ADDENDUM #1

March 17, 2022

TO: ALL MANDATORY Pre-Bid Meeting Attendees
PROJECT NAME: Contract 76 B.1-Biological Foul Air Mitigation System-Construction-Rebid
BID REFERENCE #: 91359-003.0
BID DUE/OPENING DATE: Tuesday, March 29, 2022 at 3:00 p.m. Local Time

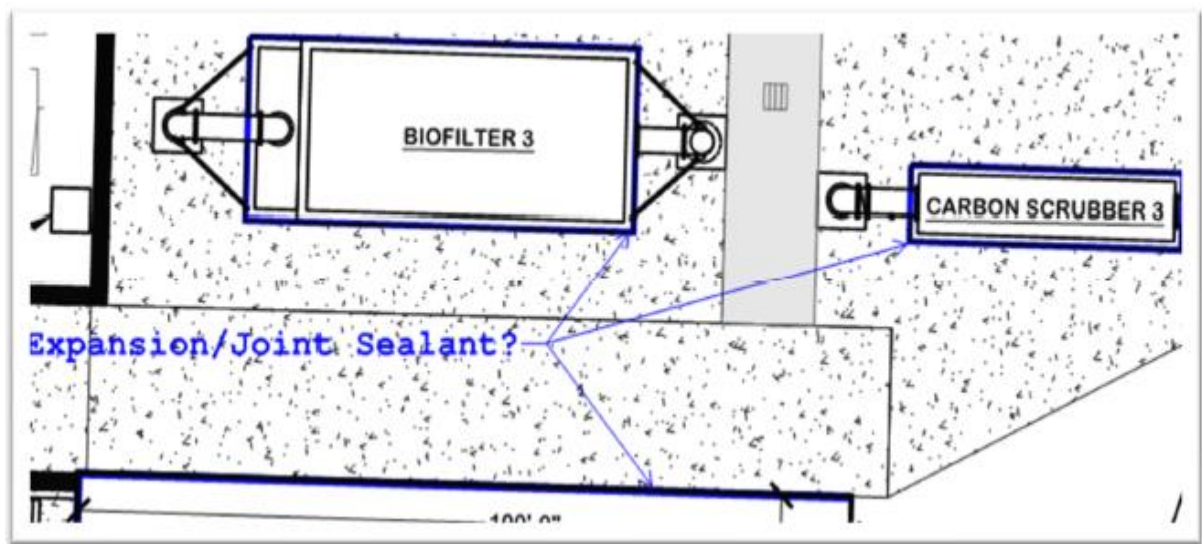
Q3: Do you expect us to install expansion/joint sealant at the new site and building concrete interface as shown below?

A: Yes, detail “Perimeter Isolation Joint” on sheet S-6 (page 19 of 44 of original Bid Document, Attachment D, Drawings/Plans) shall be utilized where a concrete slab meets a foundation wall. Rigid Insulation may be omitted around Carbon Scrubber Foundations. Detail shall also be used at joints where any two (2) non-continuous concrete pours meet.

Typical Concrete Encased Conduit Detail

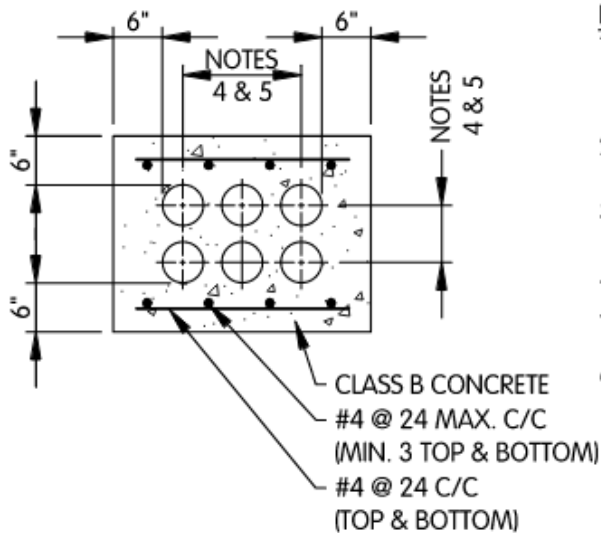
Add the attached Typical Concrete Encased Conduit Detail (*Attachment B*) to the Bid Document specifications when submitting bids for this project.

1. ALL DUCT BANKS TO BE REINFORCED UNDER ALL EXISTING & PROPOSED ROADS, DRIVES AND PARKING AREAS.
2. REINFORCING TO EXTEND A MINIMUM OF 5'-0" FROM EACH SIDE OF PAVEMENT.
3. REINFORCING SHOWN IS TYPICAL FOR ALL SIZES OF DUCT BANKS.
4. 7½" MIN.SPACING EXCEPT TO SIGNAL COND.
5. SIGNAL CONDUITS TO BE MAINTAINED 12" MIN. FROM ALL OTHER.
6. THE CONCRETE ENCASEMENT OF ANY NUMBER OF CONDUITS ONE THROUGH SIX CONDUIT(S) SHALL USE THIS DETAIL AS AN EXAMPLE OF AN INSTALLATION. CROSS SECTIONAL SIZE SHALL VARY WITH THE NUMBER OF CONDUITS REQUIRED.

Additional Details and Example Photos

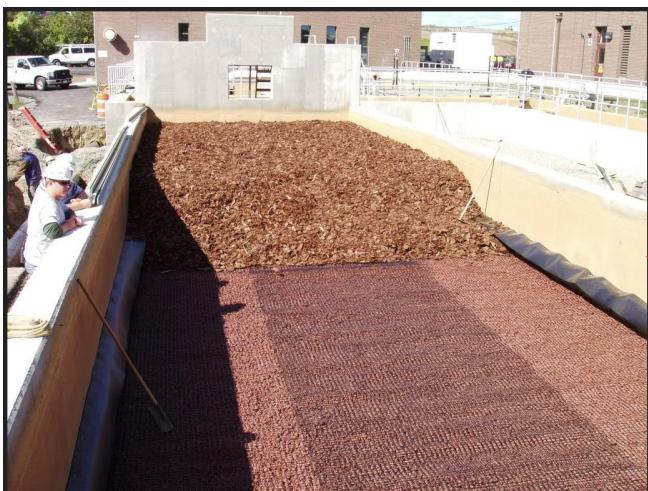
Q4: Is there a list of support grading, media, etc. for bidders to figure out labor costs?

A: Media volume is approximately 800 CY per biofilter. Media will be delivered in flexible intermediate bulk containers (FIBCs) with a capacity of approximately 1 CY each. Each FIBC may have a full weight of up to 4,000 lbs. Please see *Attachment C* and *Attachment D* for additional information.

Typical HMA Pavement Section

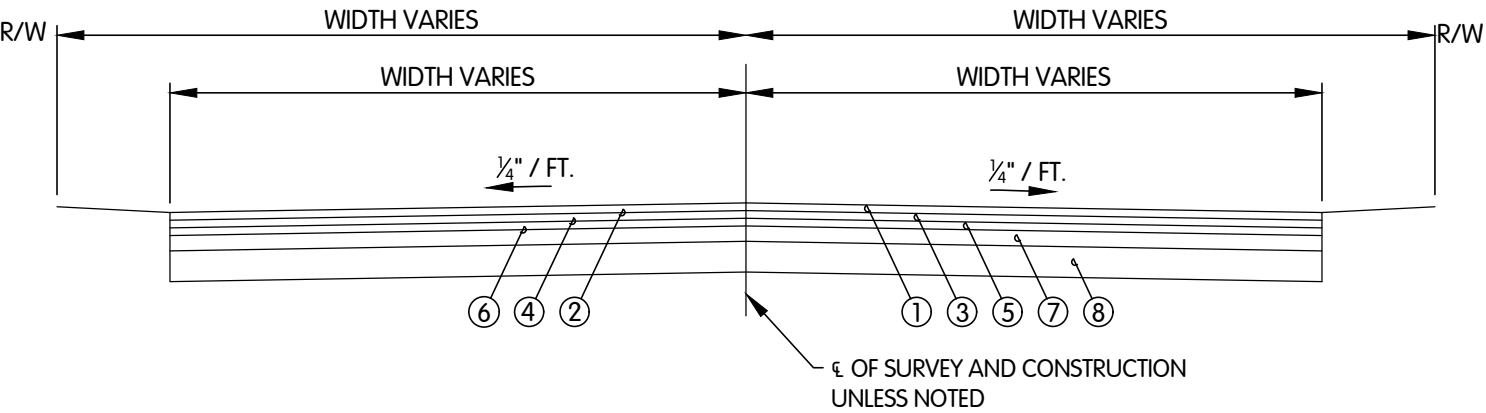
Q2: There does not appear to be any asphalt paving cross-section(s) in the plans or the specs. Could you please provide a cross-section detail?

A: Please see attached detail (*Attachment E*).

- ① 2" MDOT HMA 13A WEARING COURSE
- ② TACK COAT 0.05 GAL/SQ.YD.
- ③ 2" MDOT HMA 13A LEVELING COURSE
- ④ TACK COAT 0.05 GAL/SQ.YD.
- ⑤ 2" MDOT HMA 2C BASE COURSE
- ⑥ PRIME COAT 0.10 GAL/SQ.YD.
- ⑦ 8" CIP MDOT 22A AGGREGATE BASE
- ⑧ 24" CIP MDOT GRANULAR MATERIAL CLASS III SUBBASE
